RESPONSES TO COMMENTS ON THE DRAFT SUBSEQUENT ENVIRONMENTAL IMPACT REPORT Volume 1

Balboa Reservoir Project

SAN FRANCISCO PLANNING DEPARTMENT
CASE NO. 2018-007883ENV
STATE CLEARINGHOUSE NO. 2018102028

DATE: April 29, 2020
TO: Members of the Planning Commission and Interested Parties
FROM: Lisa Gibson, Environmental Review Officer
Re: **Attached Responses to Comments on Draft Subsequent
Environmental Impact Report Case No. 2018-007883ENV
[Balboa Reservoir Project]**

The geographic context for the analysis of cumulative impacts is the transportation study area shown on Figure 3.B-1, p. 3.B-7.

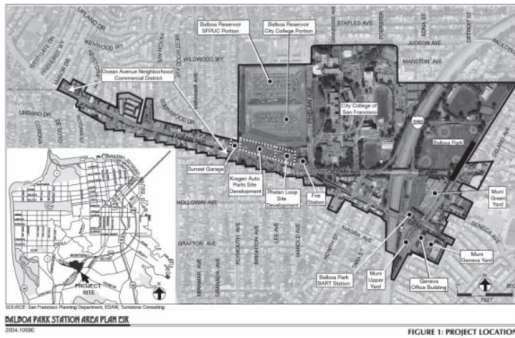
The geographic context for the analysis shown in Fig. 3.B-1 is limited to an eastern boundary of Frida Kahlo Way. This eastern boundary is inappropriately restrictive.
